SERVICE BULLETIN

No. 191

Piper Aircraft Corporation

SUBJECT: Aileron Hinge Bracket - Part No. 20211-00

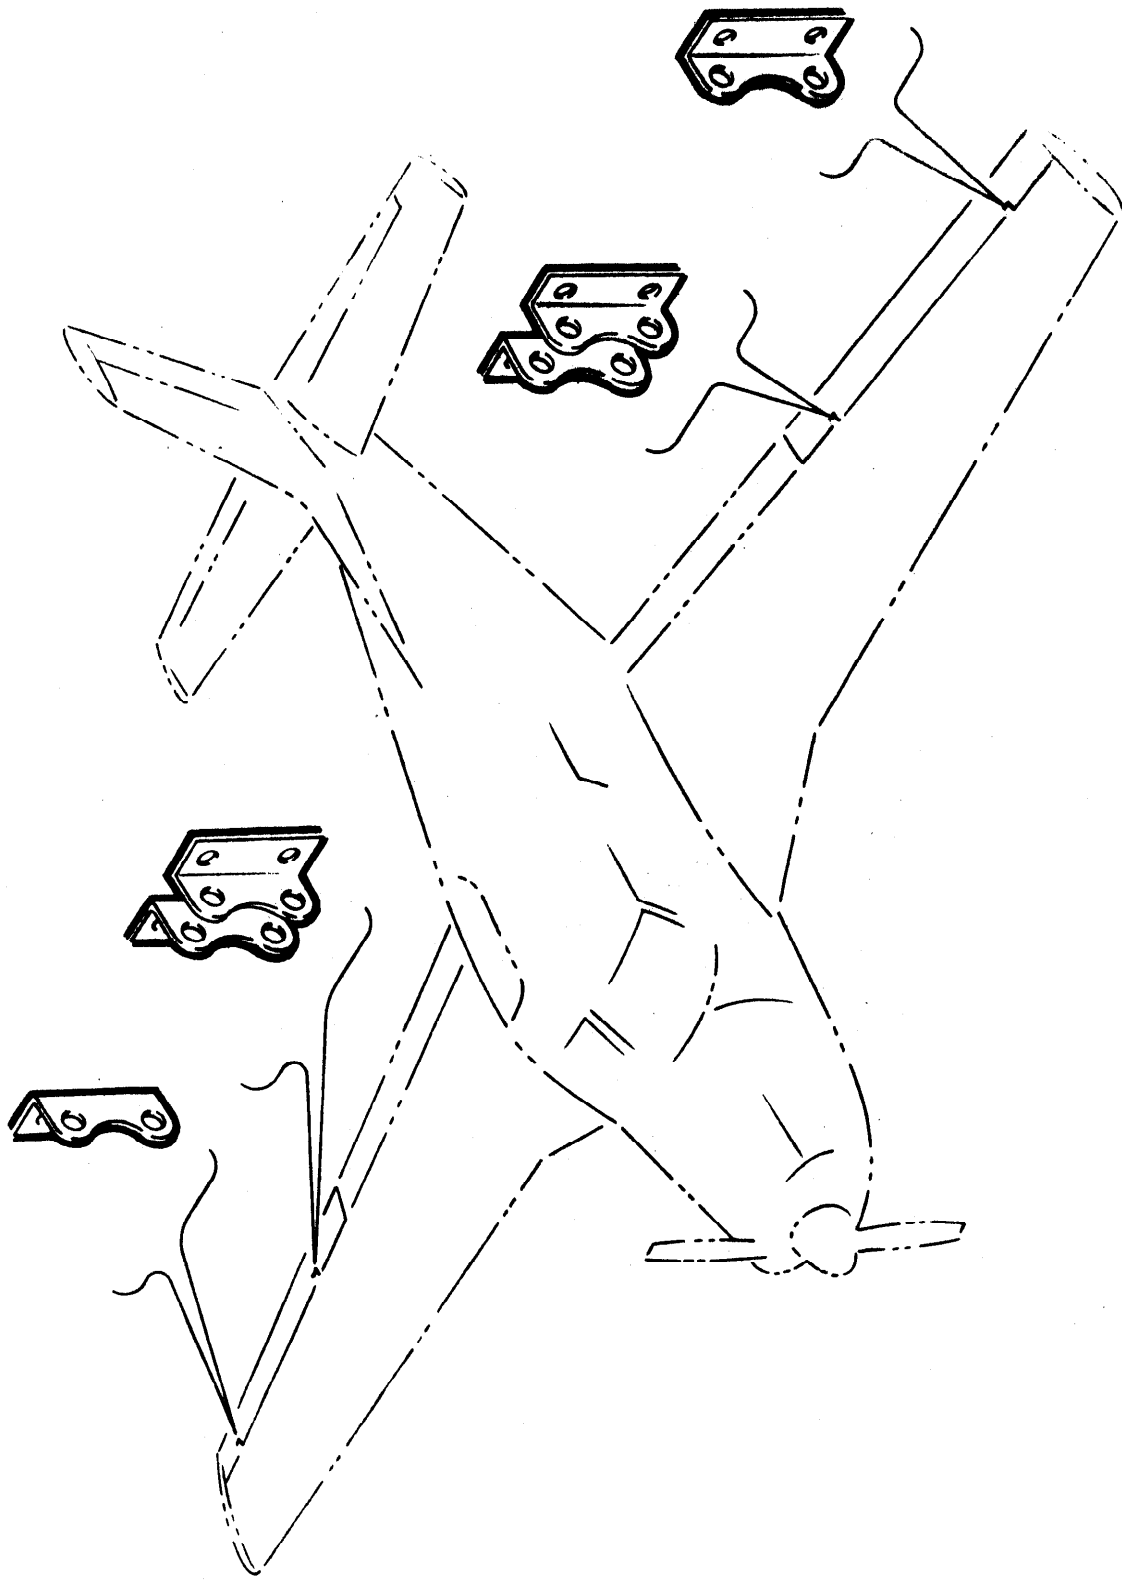
It has been brought to our attention in a recent report from the field that a crack was discovered in one of the subject aileron hinge brackets, part number 20211-00.

This report is an isolated case, however, we feel that a visual inspection of these brackets should be made on all Comanches as indicated by the above serial numbers and any cracked brackets should be replaced.

Reference to the sketch on the reverse side of this bulletin will indicate the location of these brackets.
